## Addendum No. 1

Project: Burgess/Norton/Dakota Halls Water Main at USD  
OSE # RO618-13X  
Vermillion, South Dakota

Engineer: Paul J. Korn, PE  
Sayre Associates, Inc.

# EXHIBIT A

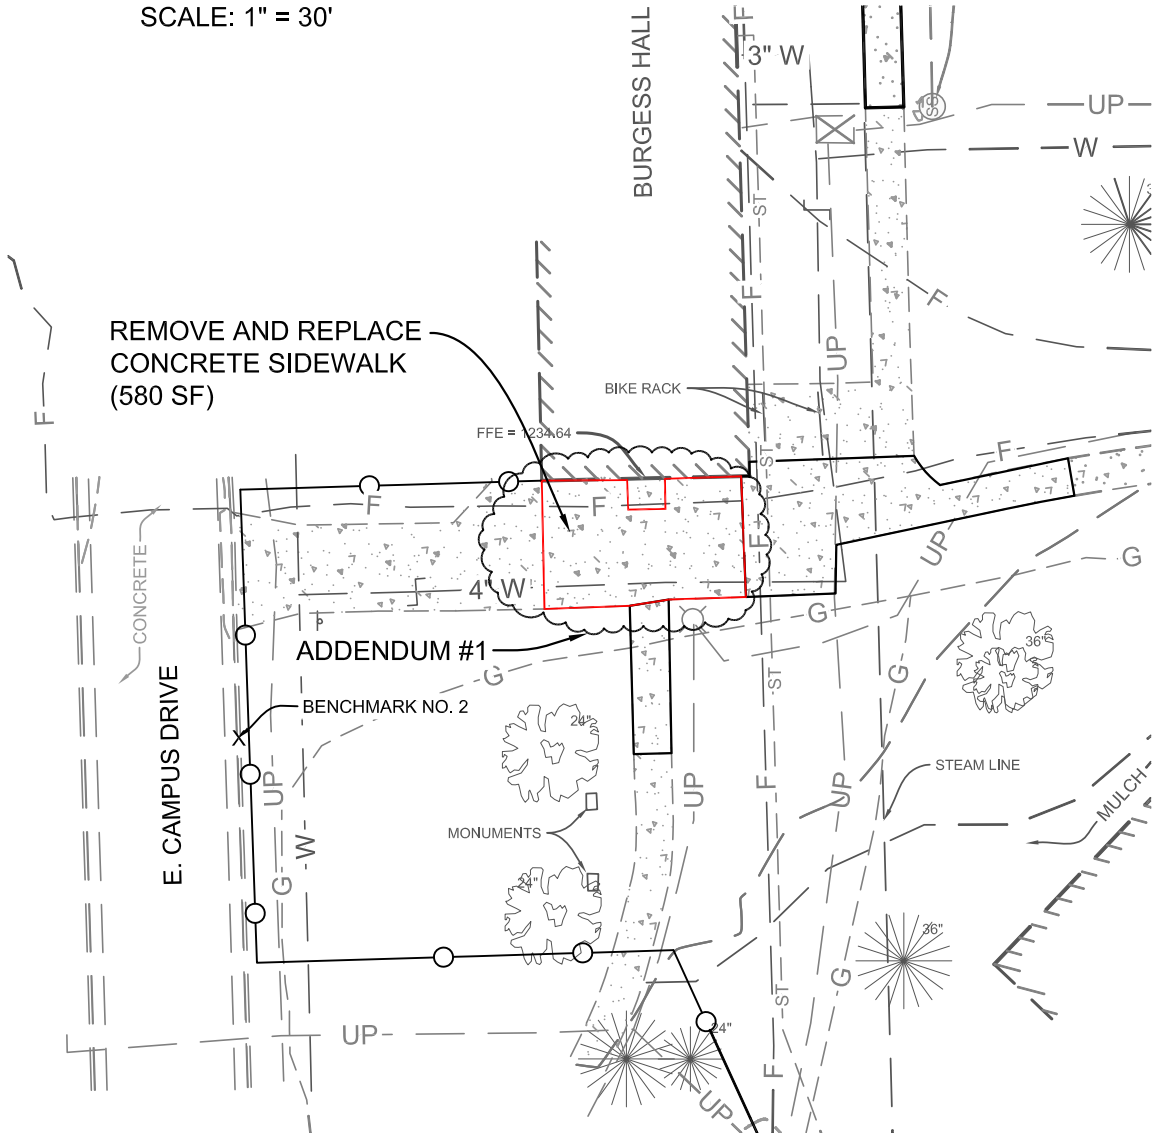
### Sheet 5 and Sheet 6 – Sidewalk Removal & Replacement:

The Contractor shall include in the base bid the removal of 64.4 SY of additional concrete sidewalk and placing 580 SF of additional 5" concrete sidewalk adjacent to Burgess Hall as indicated on attached Exhibit A.
